SUB-COMMITTEE ON STABILITY AND
LOAD LINES AND ON FISHING VESSELS
SAFETY
54th session
Agenda item 9

SLF 54/9/2
9 November 2011
Original: ENGLISH

**DEVELOPMENT OF PROVISIONS TO ENSURE THE INTEGRITY AND UNIFORM
IMPLEMENTATION OF THE 1969 TM CONVENTION**

**Proposals for solutions to the issues previously identified with
the 1969 TM Convention**

FIG. 1

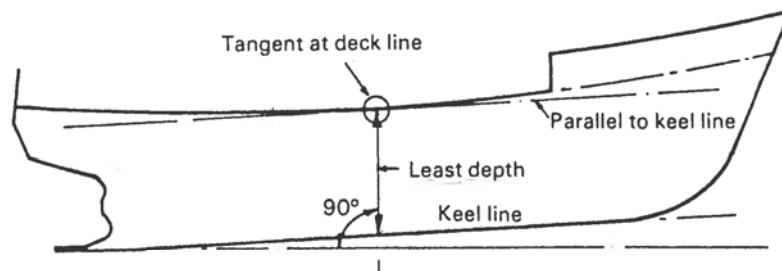
IACS' suggested solution is agreed. For the sake of clarity, the adoption of figures 1 and 2, set out below, should be considered.

FIG. 2

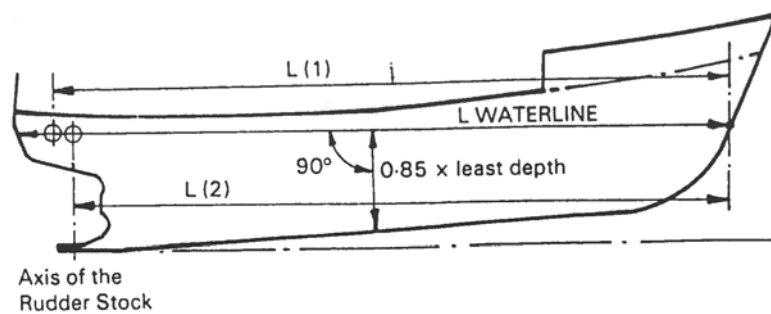
1. $L = 0.96$ OF THE TOTAL LENGTH ON A WATERLINE AT 85 PER CENT OF LEAST DEPTH

FIG. 3

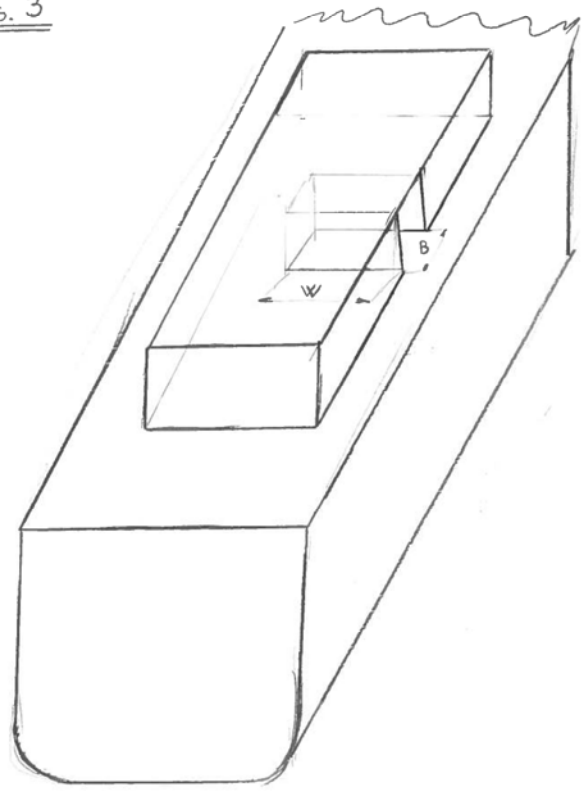
IACS suggested solution is agreed but we believe that there is a need for specifying that the bounded bulkheads can also be fitted with access doors. It would also be necessary to clarify that recesses located at the side of the erection can be excluded from GT even though the recess extends for more than one tier. Figure 3 and 4, set out below, may be referred to in this context.

$W > 2B$
RECESS IS EXCLUDED
BECAUSE OPEN AT SIDE

FIG. 4

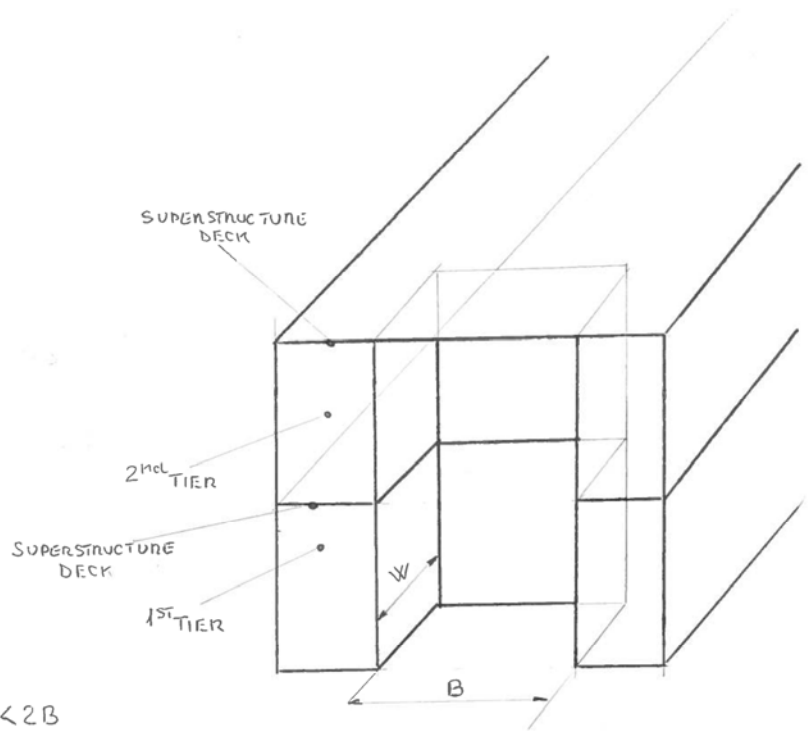
$W < 2B$
RECESS IS EXCLUDED
ALSO IF EXTENDED FROM MORE
THAN TWO DECKS
